COA (SP) 2025-026  
December 18, 2025

**STAFF REPORT  
ACCELERATED SPECIAL CERTIFICATE OF APPROPRIATENESS  
FOR THE PROPERTY AT  
826 ORTEGA AVENUE  
A LOCAL HISTORIC LANDMARK**

**Proposal:** The application requests design approval for additions and alterations to the residence and sitework. Variances have also been requested from Article 2, Section 2-101 D (4 & 5) of the Coral Gables Zoning Code for the front and side setback, Article 13, Section 13-303 of the Coral Gables Zoning Code for enlarging a non-conforming structure, and Article 2, Section 2-101 D (6) a. of the Coral Gables Zoning Code for the minimum separation between the primary residence and the pool and gazebo.

Figure 1: 1930 photo (top); ca. 1940s photo (middle); Current photo, 2025 (bottom)

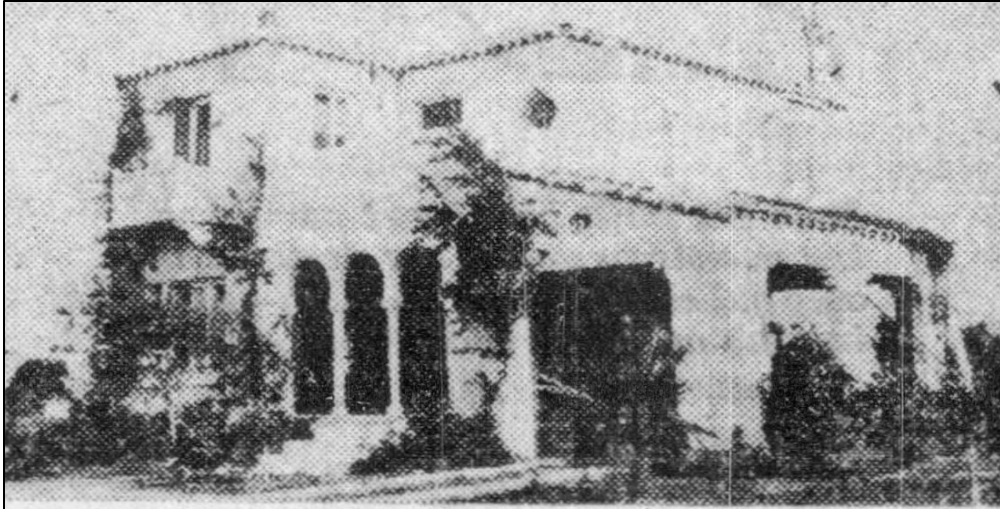
The application requests design approval for a covered entry addition and alterations to the residence and sitework. The front entry, as seen in Figures 1, was altered at some point by the 1940s from its original triple arch configuration. The current entry configuration is not appropriate for the home. The current proposal, while not restoring the original or 1940s entry, is more appropriate to the Mediterranean Revival style of the home than what currently exists.

**Figure 2: Site Plan, BLDR-24-10-6285**

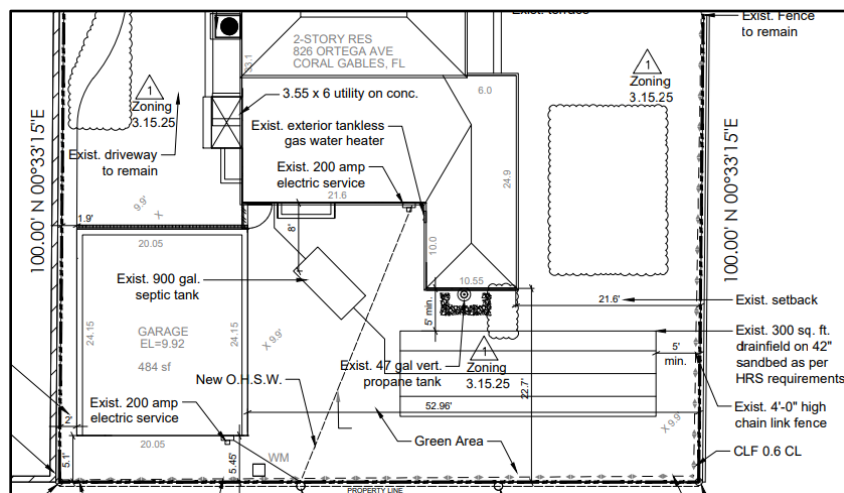
Grant a variance to allow the edge of the pool deck, pool water edge and gazebo to have a side setback of three feet six inches (3'-6") vs. the required minimum side setback in Single-Family Residential Districts shall be approximately nine feet five inches (9'-5") pursuant to Article 2, Section 2-101 D (4 & 5) of the Coral Gables Zoning Code.

The proposed swimming pool, deck, gazebo are located in the side yard to the east of the residence. Because the 1920s house was sited so far forward on the lot as noted above, the septic tank and drain field are located to the rear of the home (see below). The side yard is the only location for any site improvements. The Code requires a 15'-0" overall side setback on this property. Because the existing original carport is 5.65' from the west property line, the required east setback is 9.35' which would render the side yard unusable for a pool or gazebo. Please note that the water's edge of the pool is noted to be at 7'-6" from the property line with the pool deck edge at 3'-6".

Grant a variance to allow the closest edge of the gazebo and pool water edge a minimum separation from the residence of three feet (3'-0") vs. the required minimum separation in Single-Family Residential Districts of five feet (5'-0") pursuant to Article 2, Section 2-101 D (6) a. of the Coral Gables Zoning Code.

As noted above, the only location for a pool and/or gazebo is in the side yard. Because the side yard is narrow, the proposed pool and gazebo are closer to the house than is allowed by Code.

A motion to **APPROVE** a variance to allow the edge of the pool deck and pool water edge to have a side setback of three feet six inches (3'-6") vs. the required minimum side setback in Single-Family Residential Districts shall be approximately nine feet five inches (9'-5") pursuant to Article 2, Section 2-101 D (4 & 5) of the Coral Gables Zoning Code.

A motion to **APPROVE** a variance to allow the closest edge of the pool water edge a minimum separation from the residence of three feet (3'-0") vs. the required minimum separation in Single-Family Residential Districts of five feet (5'-0") pursuant to Article 2, Section 2-101 D (6) a. of the Coral Gables Zoning Code.
